**Explanation of Significant Differences (ESD) for the
Revision 1 Interim Record of Decision
Remedial Alternative Selection for the
E-Area Low-Level Waste Facility, 643-26E
(Slit Trench Disposal Units 1 and 2) (U)**

SRNS-RP-2009-01128

Revision 1

January 2010

Figure 3. Operational Stormwater Runoff Conceptual Design

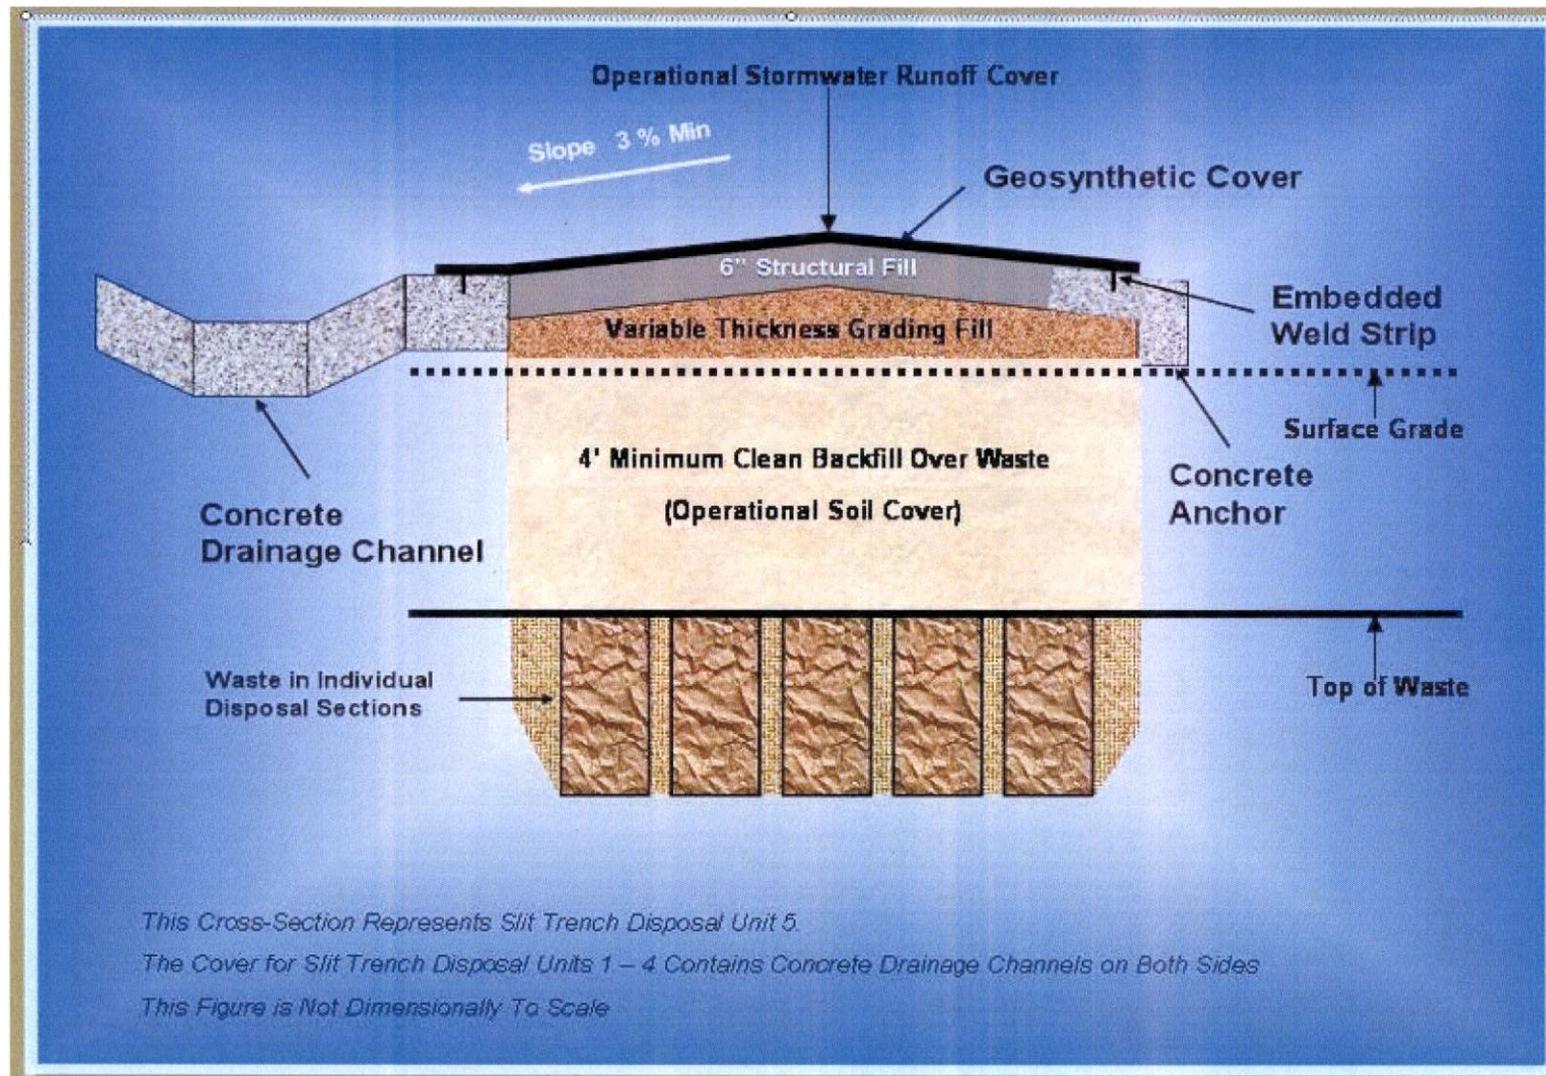
Figure 3 illustrates the conceptual stormwater runoff cover design for Slit Trench Disposal Units 1 through 5. Construction of the operational stormwater runoff covers will involve the placement of grading fill and structural fill over the operational soil cover, which will be graded to promote even greater drainage off the trenches. The runoff cover will consist of a low-permeability, 30 mil (minimum thickness), EIA cap liner. Sloping under and around the cover material will be adequate to ensure cover stability and promote positive drainage. A soil layer will not be installed over the barrier cover material; this will allow for visual inspection during both the construction and operational period. The exposed geomembrane liner will allow for easier and faster detection of damage to the cover system and allow for immediate visual detection of
